Type of Notification: Subcomponent Manufacturer Change

| ISSUE DATE | LAST BUY DATE | NOTIFICATION NO. | LAST SHIP DATE |
|--|---------------|------------------|----------------|
| 7 December 2006 REVISED: 1 March 2007 | N/A | PCN-20061207-01 | N/A |

LQ104V1DG51 LCD Module

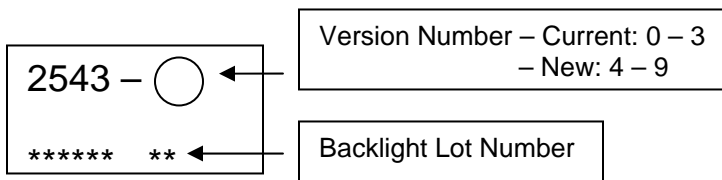
The current manufacturer for the optical films used in the LQ104V1DG51 is discontinuing their production. Sharp will be switching suppliers as a running production change beginning in April, 2007. (The earlier announcement had this date as February, 2007.)

The version number as shown on the backlight sticker below will be revised.

| TYPE OF FILM | BEFORE | AFTER |
| Optical film | DBEF-M | DBEF-II |
| Lens film | BEF III | GTL 5000F |
